BLUE FOLDER ITEM

PLANNING COMMISSION MEETING September 15, 2022

- J.1.** A PUBLIC HEARING FOR CONSIDERATION OF AN ENVIRONMENTAL ASSESSMENT (ENVIRONMENTAL IMPACT REPORT - STATEMENT OF OVERRIDING CONSIDERATIONS AND MITIGATION MONITORING AND REPORTING PROGRAM), VARIANCE, COASTAL DEVELOPMENT PERMIT, CONDITIONAL USE PERMIT (DENSITY BONUS), PLANNING COMMISSION DESIGN REVIEW, AND VESTING TENTATIVE MAP NO. 82561 TO PERMIT CONSTRUCTION OF A PROPOSED 30-UNIT RESIDENTIAL PROJECT WITH ADAPTIVE REUSE OF EXISTING NON-RESIDENTIAL BUILDINGS FOR COMMERCIAL PURPOSES ON PROPERTY LOCATED WITHIN A LOW DENSITY, MULTIPLE-FAMILY RESIDENTIAL (R-3A) ZONE, IN THE COASTAL ZONE, AT 100-132 N. CATALINA AVENUE. (CASE NOS. IES-EIR-2021-01; CUP-2022-01; VAR-2022-02; CDP-2022-03; PCDR-2022-01; VTPM 82561)

- Public written comments received after release of the agenda

2a. Examination of the A units, of 5 BDRM and 4.5 bath:

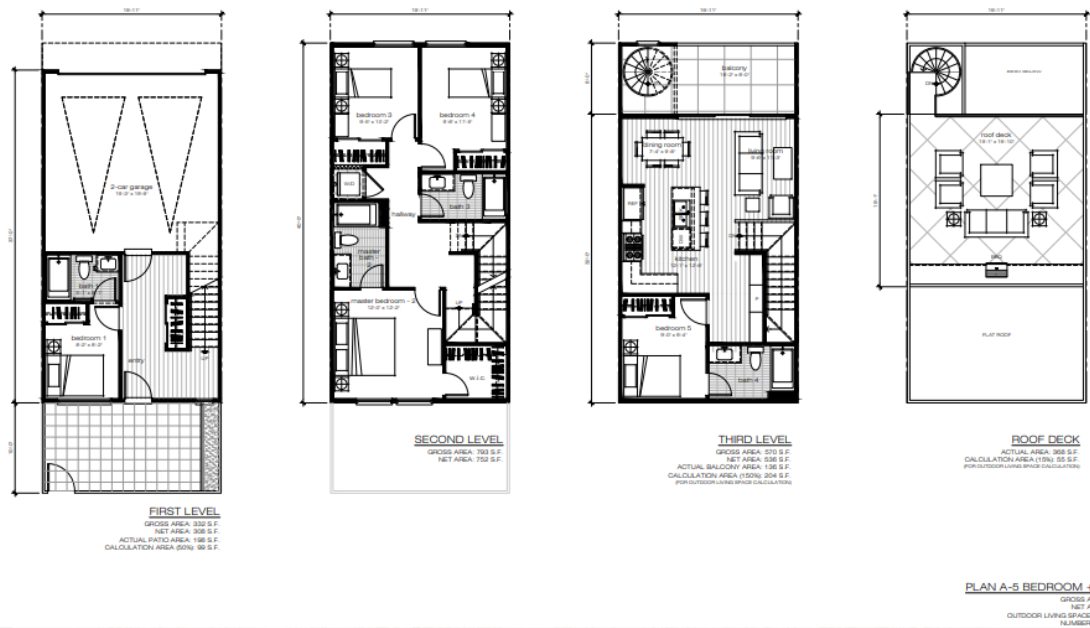
Comments:

- 1) The Plan says this is for 5 Bedrooms and 4.5 baths. A careful searching of all floors did not reveal a half bathroom anywhere. (Is there an outhouse in the setbacks?)
- 2) The garage width is 19' 11". repeated searches of the internet have shown comments like the following:

3. Examine the bedroom on the first floor more closely: It is 8'-2" by 8'-2", or is 66.69 sq ft.

I had a tough time deciding whether this even was large as a prison cell. Well, it does meet the old prison cell standard (48 sq ft), but not the new standard (ACA) of 70 sq ft. See the copy from the internet, below.

So, it is dubious whether the garage-level "bedroom" really meets legal bedroom standards.

Who designed the bedroom/bathroom layout on the 3rd floor, which also has the kitchen/dining room/living area? In order to GET to the bathroom on that level, **one has to enter the bedroom, walk through the bedroom, and then enter the bathroom**. That is an awful layout even for families; if you are renting this out room by room, no one will take that arrangement unless you are GIVING that room away!

Note: This same ill-thought out plan with the bedroom on the top level also appears on the B1 and B2 type units.

6. Final thought on plan A. Make the units a little wider to get the garages "solid" Get rid of the roof deck.
